Product Change Notification

1. ECN #: 244946

- USBR - USB TYPE A CONNECTOR

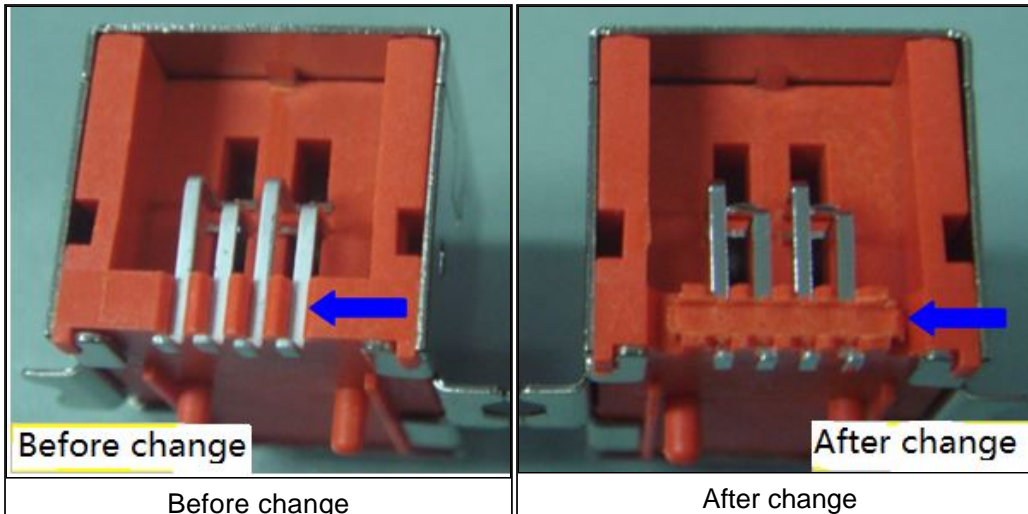
Adding heat stake process to secure surface mount tails.

Backend geometry of plastic body changed as shown.

Improve Co-planarity of the surface mount tails.

- Form - Geometry of the backend plastic body has changed due to the heat stake process.
